CALIFORNIA COASTAL COMMISSION

COASTAL DEVELOPMENT PERMIT APPLICATION

Application number3-04-030, Pebble Beach Golf Links, 5th Tee and 5th Green Seawalls

Project descriptionTwo seawalls at base of the coastal bluff to protect the 5th Tee and 5th Green, using concrete reinforced with steel tiebacks and artificial stone fascia. 5th Tee seawall: 83 feet long, with 24 feet of buried wing walls, and height varying from 43 to 46 feet; sloping from base to top of bluff; and 5th green seawall: 160 feet long with 22 feet of buried wing walls, and height from 14 to 22 feet; vertical seawall to maximum height of 22 feet, with unprotected upper bluff backfilled and vegetated to recreate 2:1 slope.

Exhibit G – pg 1 of 4
 Proposed Site Plans and Elevations

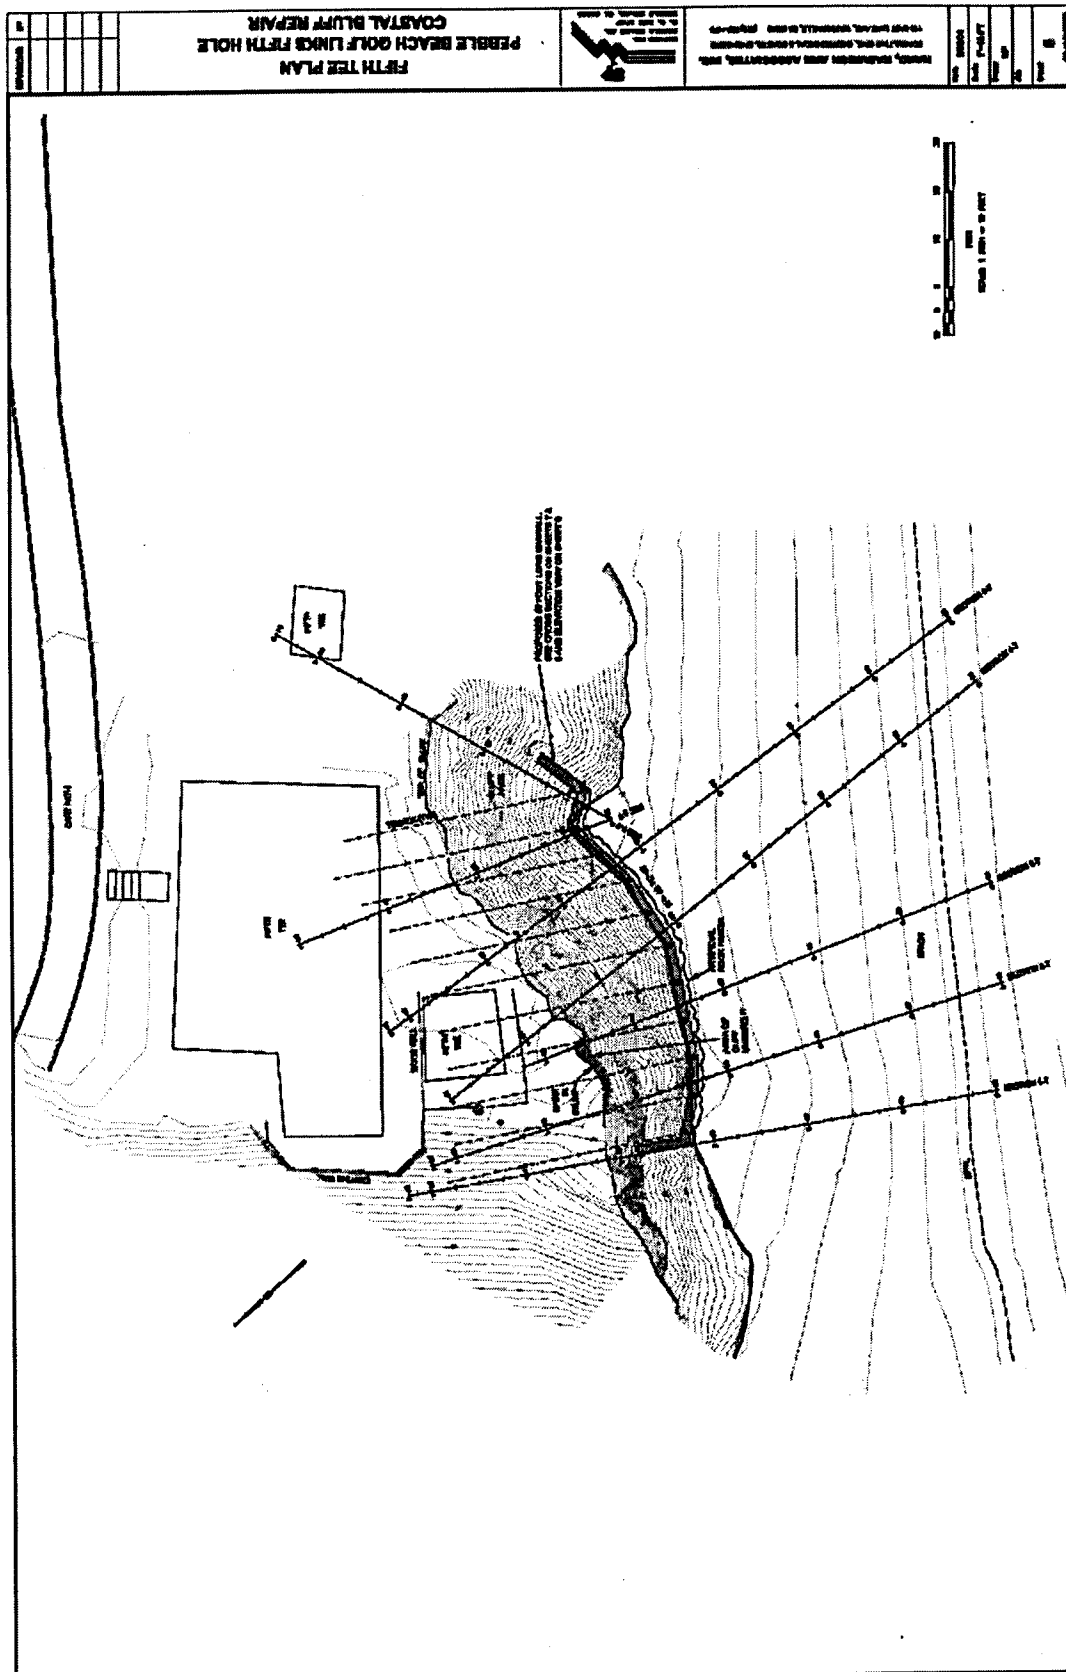
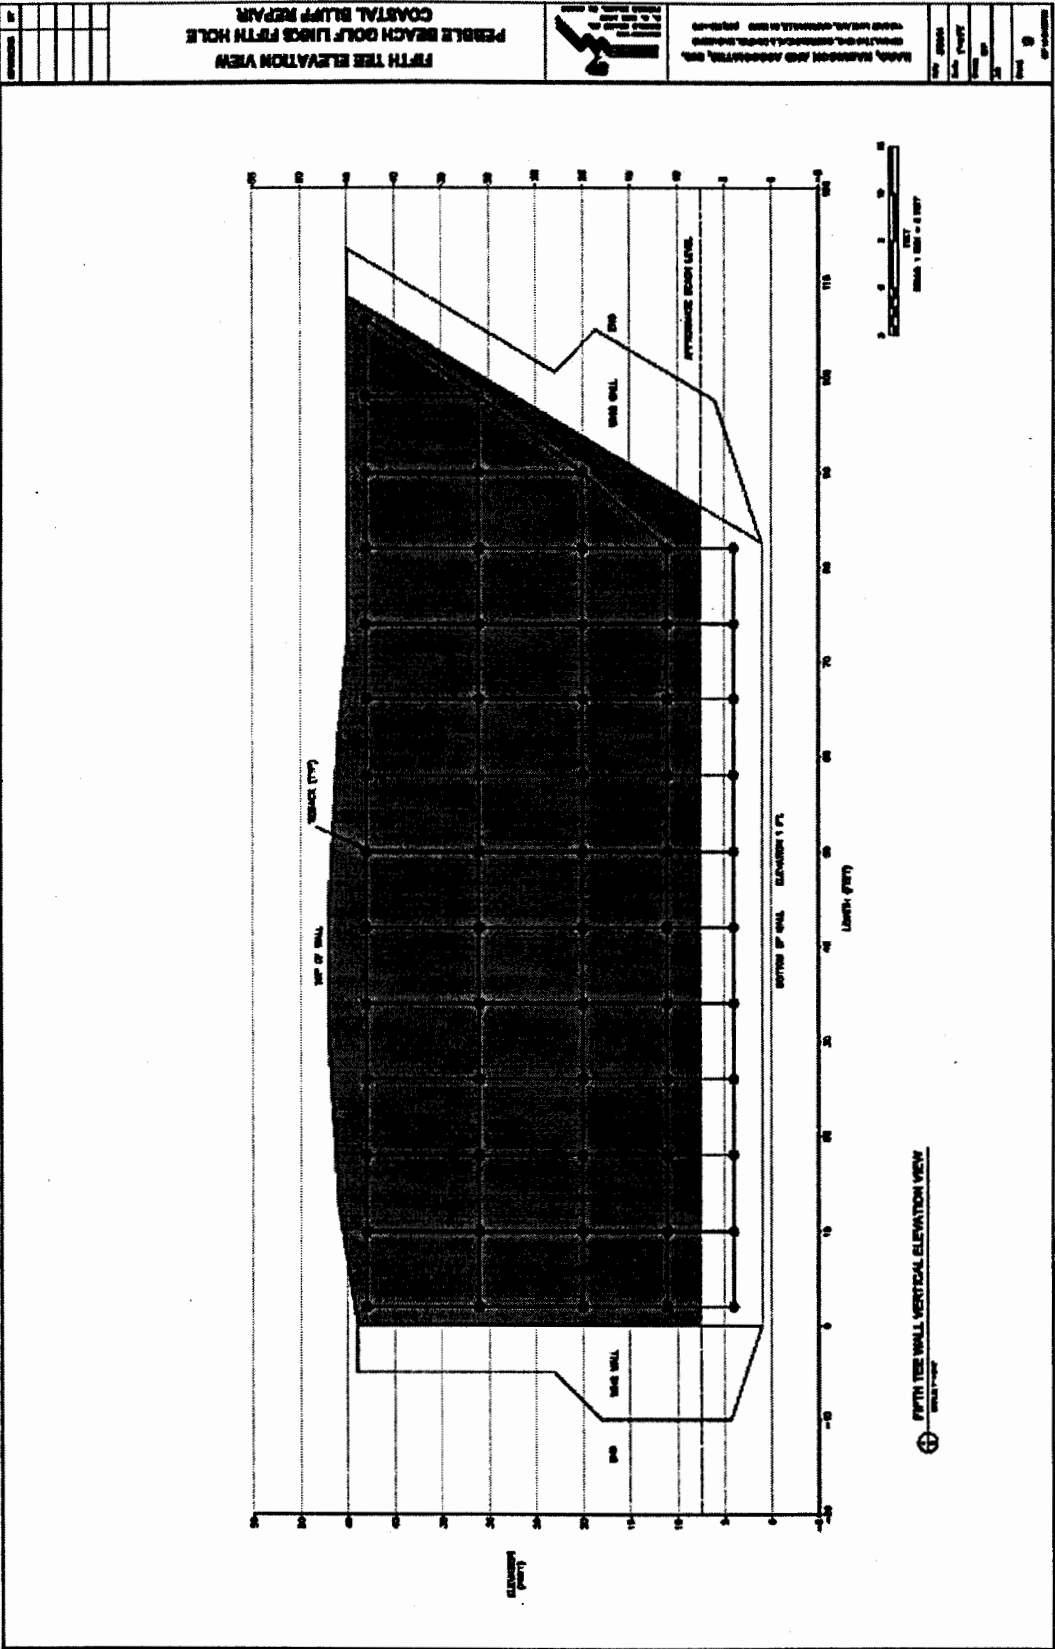
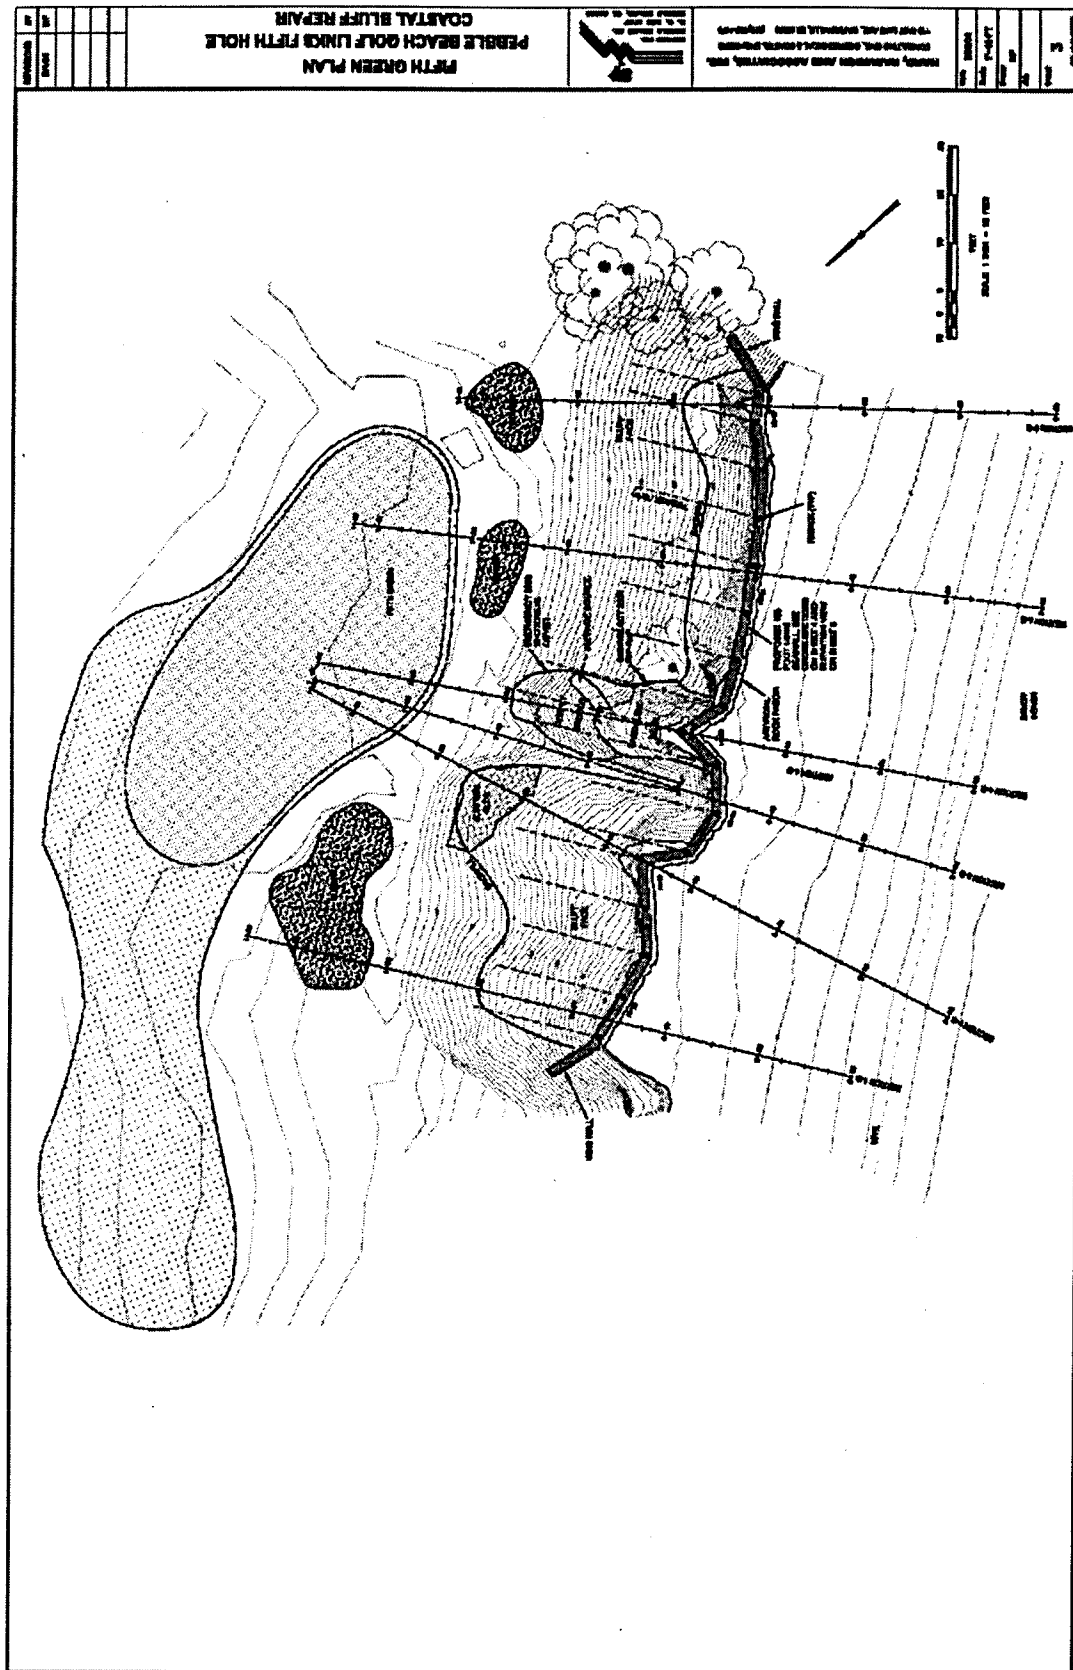
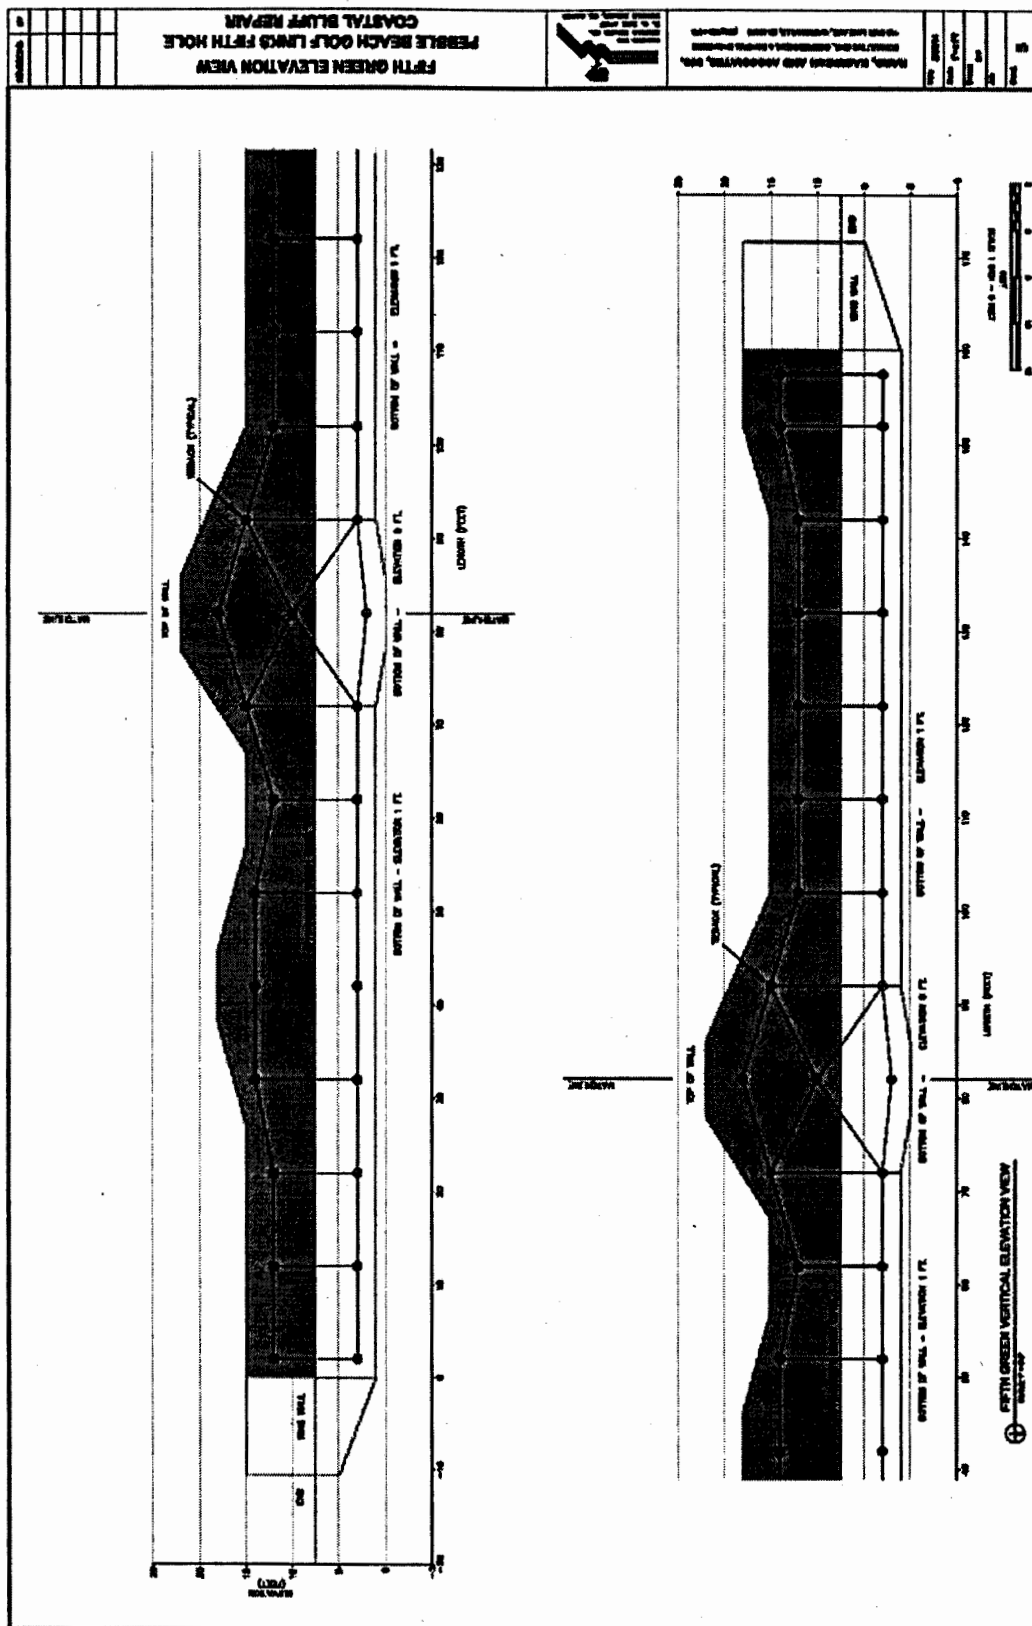
1. **Final Plans.** PRIOR TO ISSUANCE OF THE COASTAL DEVELOPMENT PERMIT, permittee shall submit final engineered plans to the Executive Director for review and approval for the following:

- A. **Final Site Plans.** Final plans shall show all components of project, including the extent of the project area (i.e., the extent of upland- and beach-based construction activities), and incorporate all geotechnical recommendations made in the geotechnical reports conducted for the project by Haro Kasunich and Associates (HKA 5/04, HKA 6/04, and HKA 8/04).

The only fill of open coastal waters will be that portion of either seawall that is keyed into the bedrock below the toe of the bluff. Consequently, the proposed seawalls will cover approximately 480 sf of beach. Project plans dated 8/04 show that the seawalls would be keyed in to bedrock to a bottom elevation of 1 foot MSL (mean high tide is at 1.6 feet MSL). Wing walls will extend 12 feet on either side of the 5th tee seawall and 11 feet on either side of the 5th green seawall to further key the walls into the existing bluff. The Coastal Commission staff coastal engineer, Lesley Ewing, reviewed the project plans, and noted that while the wing walls do extend somewhat beyond the immediate area at risk, they are not excessive, and do not require modification. She also concurred with the HKA assessment that the position of the end of the wing walls are located in the best locations to tie into the natural bluff face,

Exhibit H - pg 2 of 2
Visual Simulation of Coastal Bluff - Before and After Proposed Seawalls –
5th Green

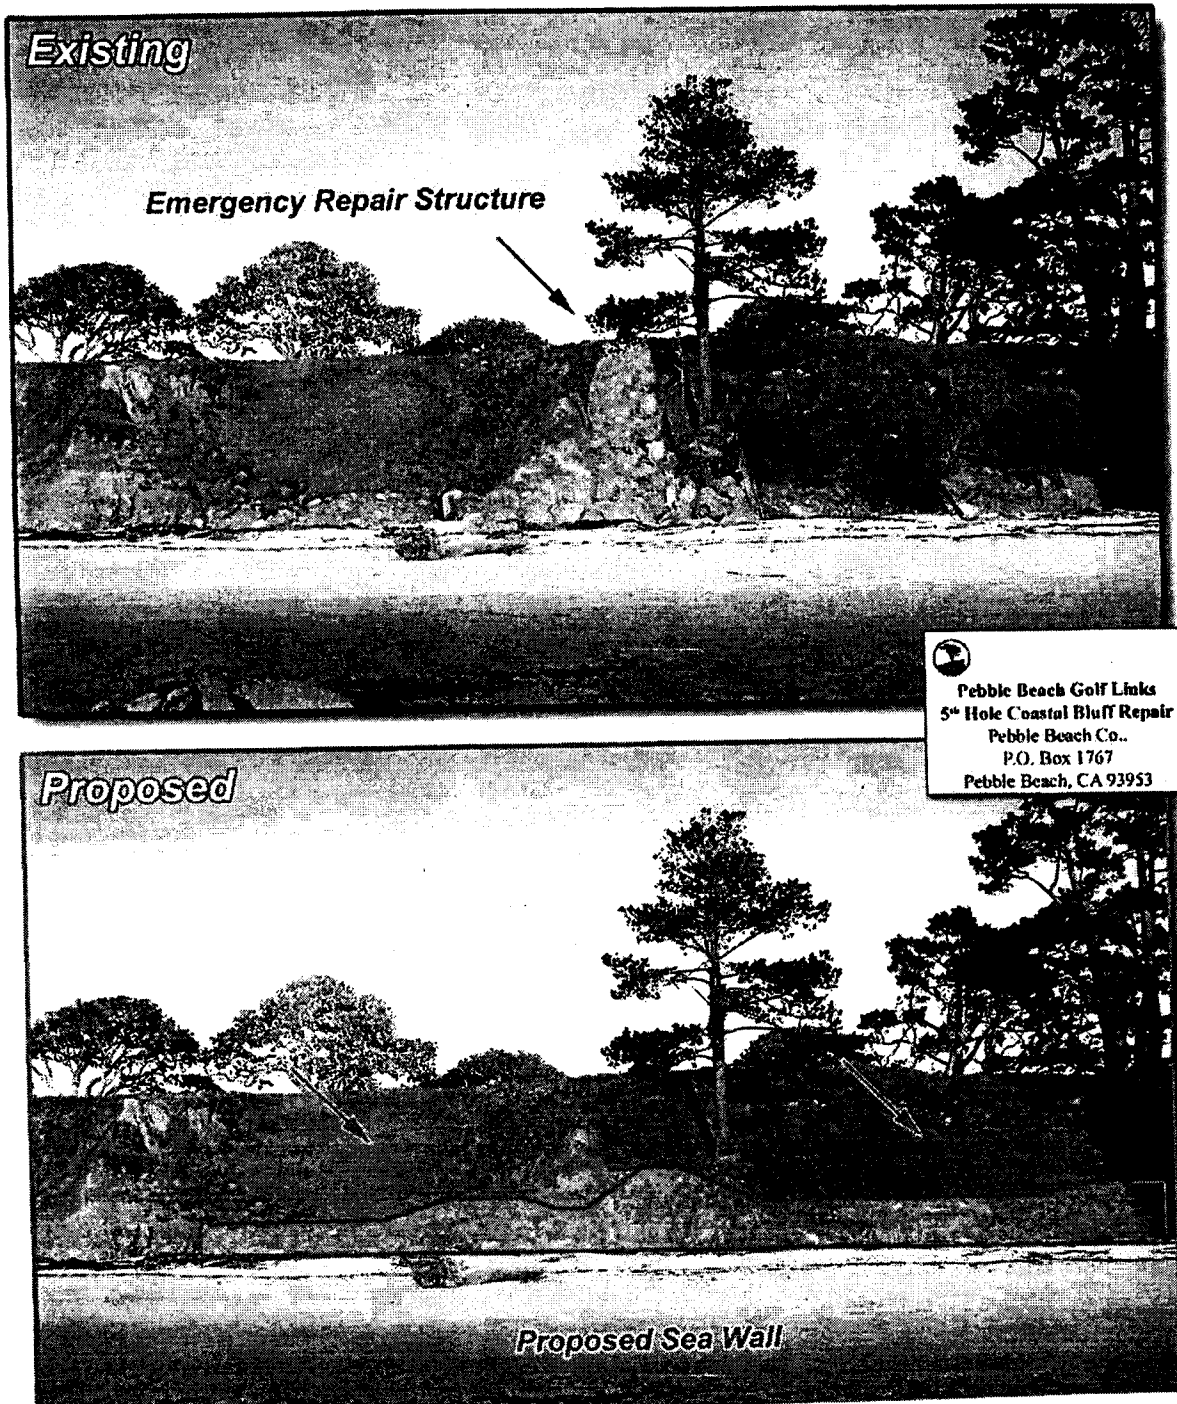
The 5th green seawall, as proposed, would be 160 feet long with an additional 22 linear feet of buried wing walls, and would vary from 14 to 22 feet in height. The 5th green seawall would be a vertical seawall, keyed into the bedrock, and set within 4 feet of the base of the bluff. The vertical seawall would be backfilled with concrete to a height just below the top of bedrock, then gravel for drainage, and then backfilled with engineered soil, and landscaped using native plants and grasses to recreate a vegetated 2:1 slope (see Exhibit H).

Furthermore, the backfilled slope and upper bluff soils above the 5th green seawall must be stabilized with vegetation appropriate to the site, and 5th green drainage shall continue to be controlled to ensure overall stability of the bluff edge. Long-rooted, non-invasive, native plant species suited for the site should be used for this purpose. In a bluff setting, these species can help to stabilize bluff soils, minimize irrigation of the bluff (again helping to stabilize the bluff), and can help to avoid bluff failure. They also create a more natural looking landform, which can help to offset the visual impacts of the seawall (see also Visual findings below).
